ADDENDUM 1

DATE: 01/30/18
PROJECT: UCT Expansion Interior Buildout
RFP NO: RFP 744-R1805 – UCT Expansion Interior Buildout
OWNER: The University of Texas Health Science Center at Houston
TO: Prospective Proposers

A1 FLOOR PLAN - LEVEL 07
SCALE: 1/8" = 1'-0"

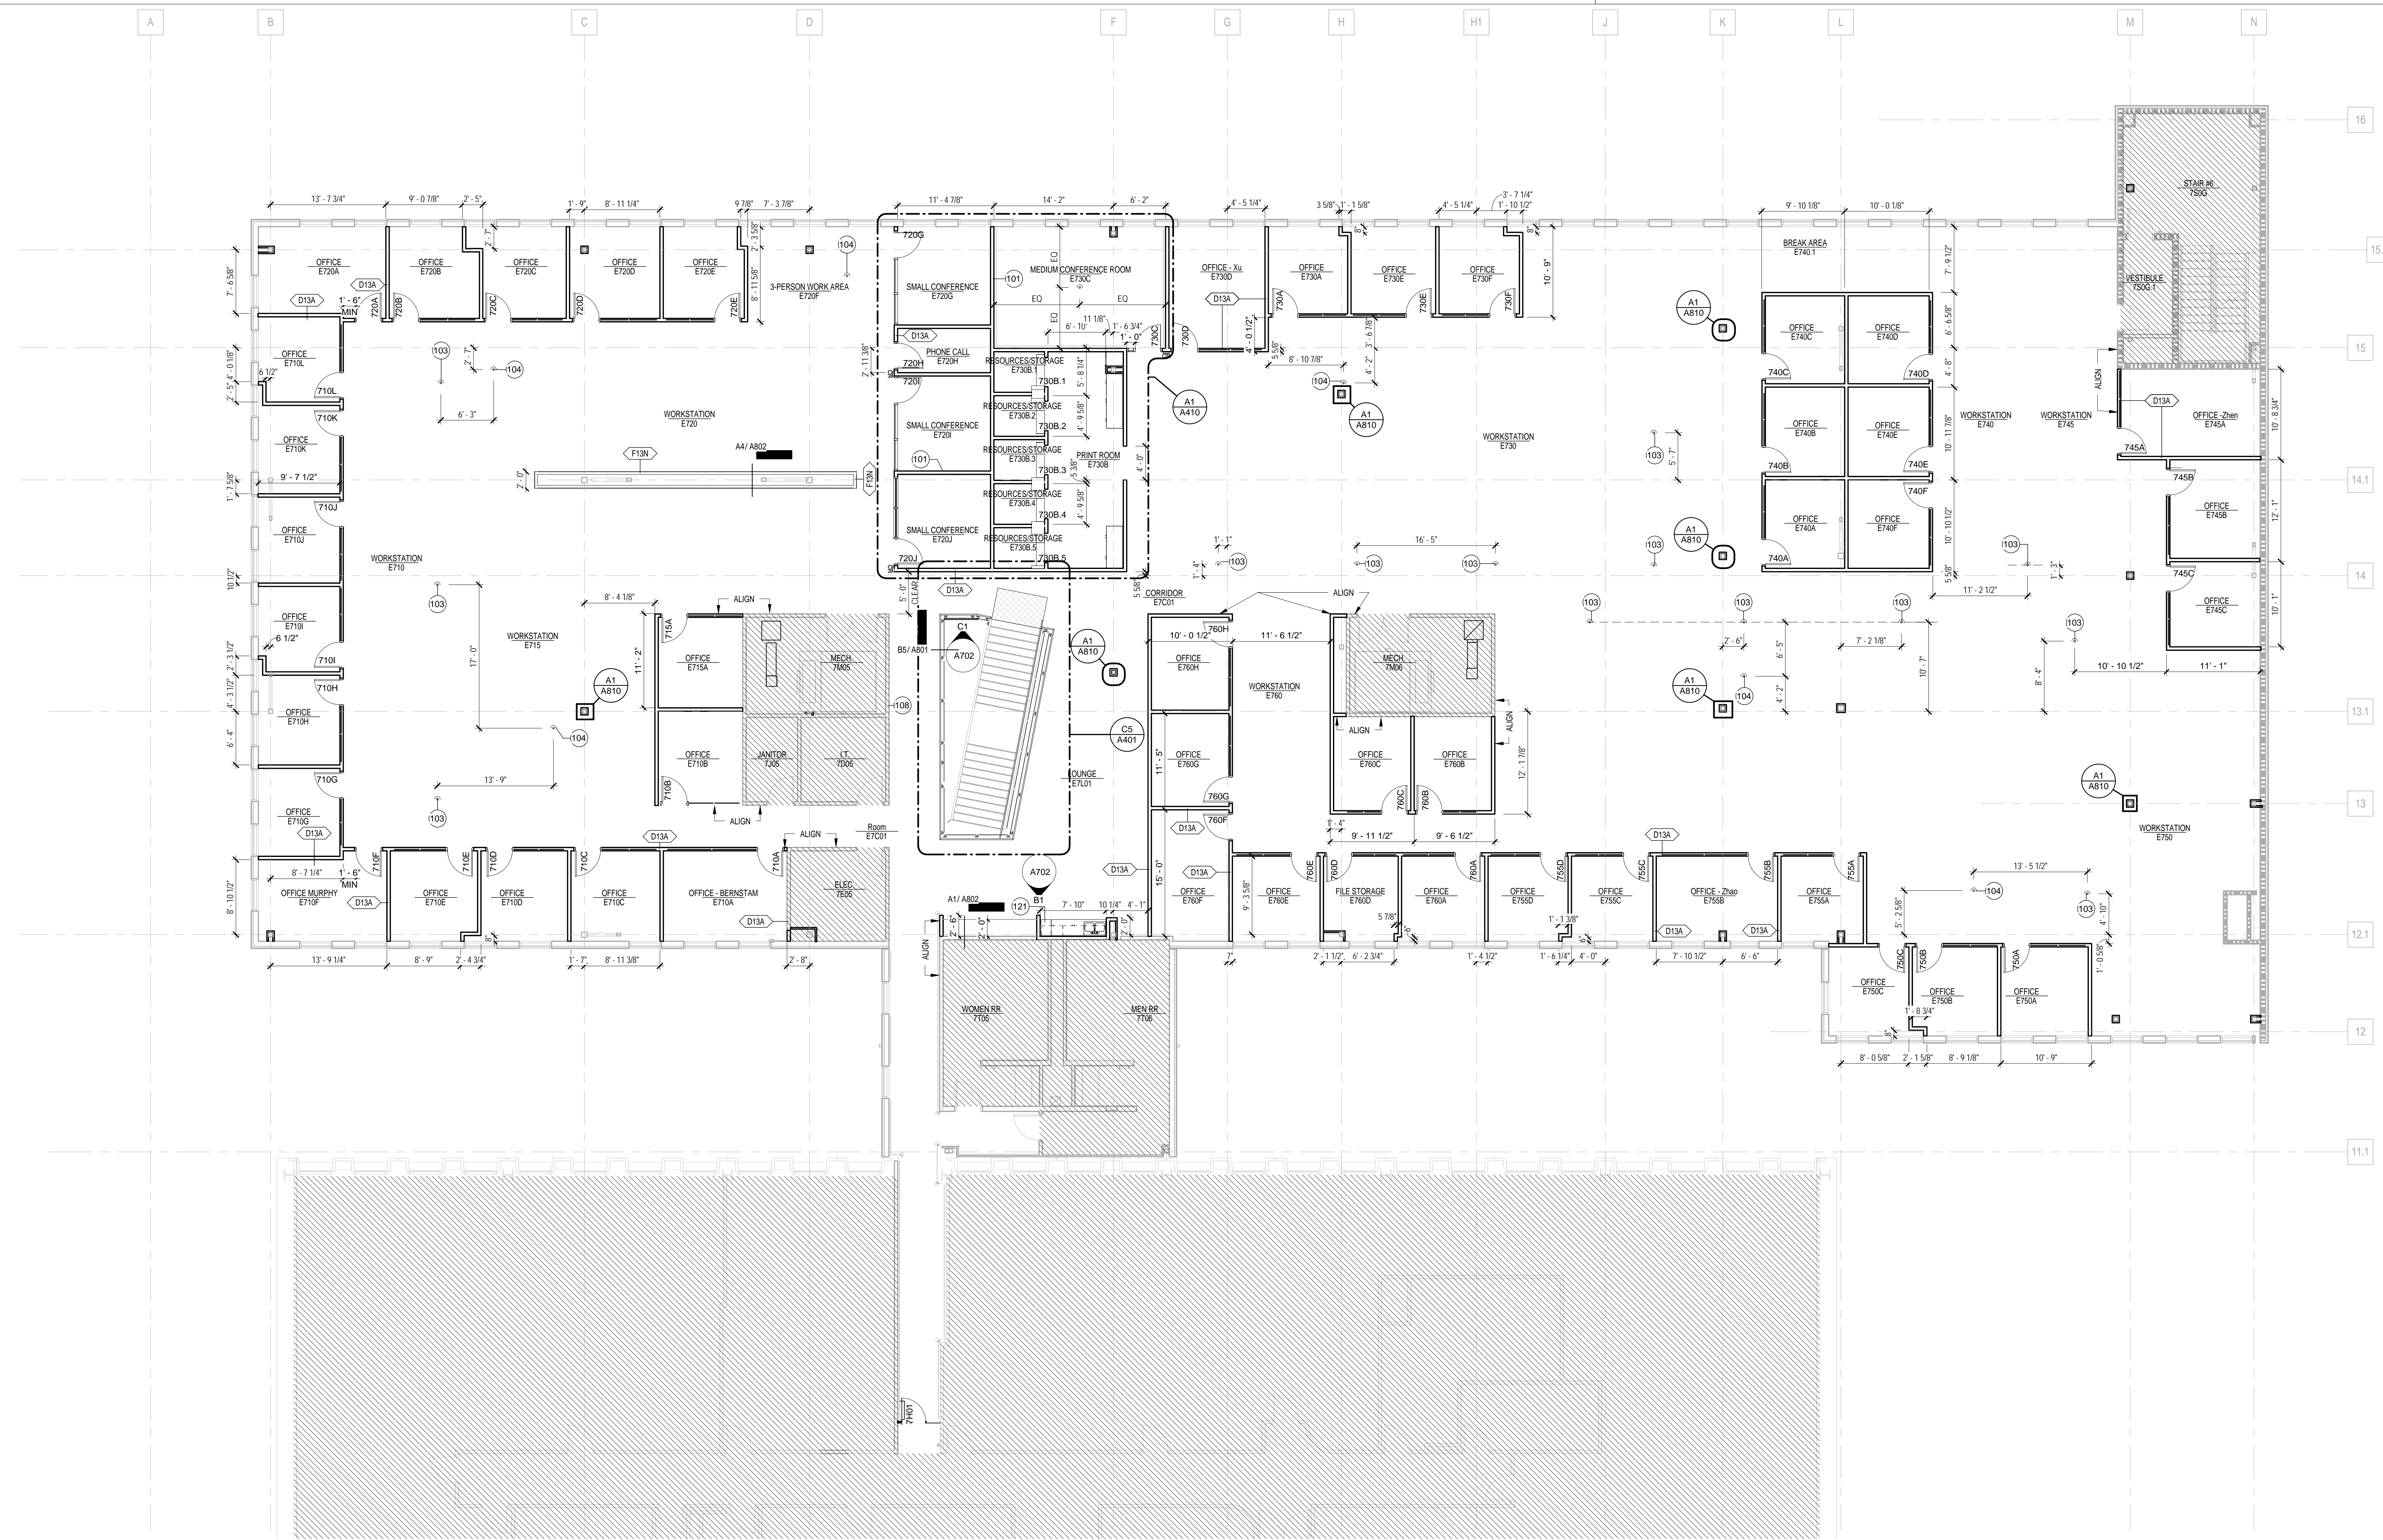
2. Sheets EP206B and EP207 state to refer to poke through schedule for more information regarding floor cores. Notes on the Sheet A106 indicate cores are existing, however, Sheet A107 indicates location of boxes but does not state if cores are existing. Please clarify if cores for poke through's are existing at 7th floor.

[Only the coring of the floor will take place during the core and shell construction. The type of floor box that will go into the already cored wholes is what the Interior Buildout project is referring to on schedules. Contractors for interior buildout should focus on the type of floor box that should go with the corresponding existing floor core.](#)
